TOWN OF ASTATULA
Planning & Zoning Commission Meeting
Thursday, December 18, 2025 – 6:00 PM
Astatula Town Hall
25009 County Road 561 | Astatula, FL 34705

TO: Town of Astatula Planning Board
CC: A. Quandt, Town Clerk
FROM: Thomas Harowski, AICP, Planning Consultant
SUBJECT: Volunteer Subdivision Final Development Plan
DATE: December 4, 2025

Town of Astatula, FL

Project Name: Volunteer Landing – Harrison Street
 Project Phase: Preliminary Plat & Civil Construction Plans (revision date 10/21/2025) digitally signed 11/20/2025 by David Glunt with Spruce Creek Civil Engineering.
 7 Single Family Lots (Zoned R-1)

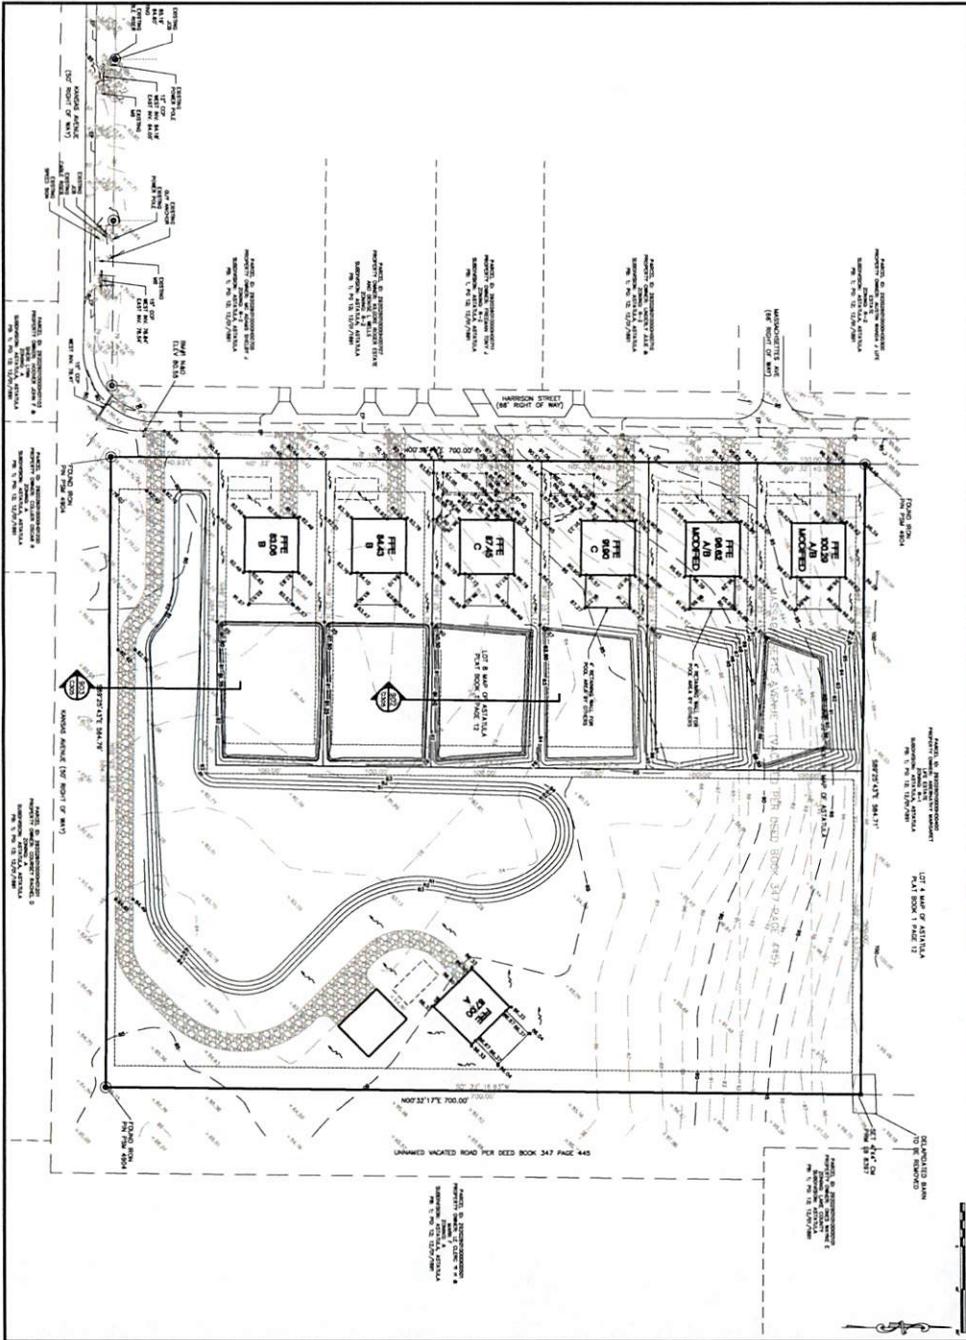
14. Indicate if there are any existing improvements including buildings, driveways, utilities, wells, etc. on the tract that will be demolished or are to remain.

****Pending.** Provide a note on the existing conditions survey about demolition. Indicate all items that will be demolished to building the project. If none, so state. ******

****2nd Review - Comment Addressed.** Barn to be demolished now indicated on C-105 and C-109. ******
